গণপ্রজাতন্ত্রী বাংলাদেশ সরকার  
শ্রম ও কর্মসংস্থান মন্ত্রণালয়  
কলকারখানা ও প্রতিষ্ঠান পরিদর্শন অধিদপ্তর

ক্যাপ পর্যবেক্ষণের তথ্য

| কারখানার নাম | আইসিয়ার ক্যাশনস লিমিটেড               |

| মূল্যায়নের ধরণ: <a href="#">কঠামোগত মূল্যায়ন</a> | পর্যবেক্ষণের তারিখ: ০৯-০৪-২০২৩ |

| পরিদর্শন<br>পর্যবেক্ষণ      | Approval drawings and As-built drawings |

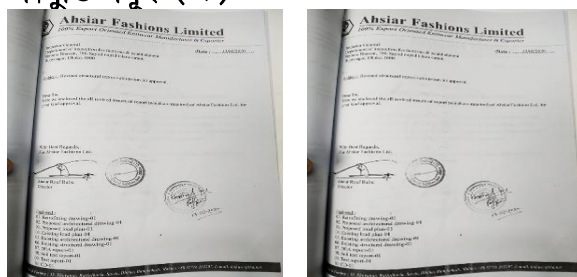
| কার্যক্রম              | As-built architectural and structural drawings of buildings to be prepared and submitted for approval by appropriate authority. As part of this process the building engineer will be required to make a number of checks on the inconsistencies between the structural design and the as-built construction.  |
| মন্তব্য                | <p>Previous timeline: 20/12/2016 Final Timeline: 08/05/2018 Factory has taken initiative and they have agreed to implement within timeline. 02/09/2020: DEA reviewed &amp; accepted on 146th Taskforce meeting. Approved drawings found in factory during visit. Retrofitting should be completed within 09/04/2020. Due to Covid-19 pandemic no retrofitting work started yet, said by factory Admin Manager. During visit we've found that there is total 3 buildings in the compound but just 2 buildings are included in design &amp; drawings. This building is adjacent to other 2 buildings &amp; this building should be included to design and drawings. All three buildings should included in the design &amp; remediated properly as per design. Now the factory management is instructed to submit all design &amp; drawings of this building along with the emergency steel stair within 15/10/2020. 28/03/2021: On 08/12/2020 on 152nd structural taskforce meeting the factory management were told to complete the retrofitting works of building 1 &amp; 2 within 31/03/2021. In the mean time the work on DEA of Building 3 should be completed. But no work regarding these issues are started yet. No retrofitting works are being started and no structural works of Building 3 are started yet. Now the factory management is instructed to start the retrofitting works of building 1 &amp; 2 immediately and submit all design &amp; drawings of the building 3 along with the emergency steel stair within 15/04/2021 by an enlisted firm of DIFE to DIFE RCC. 26.08.2021: The factory management is instructed to start the retrofitting works of building 1 &amp; 2 immediately and submit all design &amp; drawings of the building 3 along with the emergency steel stair within one month by an enlisted firm of DIFE to DIFE RCC. 23/08/2022: All Design drawings have received approval from DIFE. No retrofitting work was started. 09/04/2023: All Design drawings have received approval from DIFE. Retrofitting work has not started.</p> |

| কারখানার<br>কার্যক্রম  | We have taken initiative and it will be implemented within timeline.   |
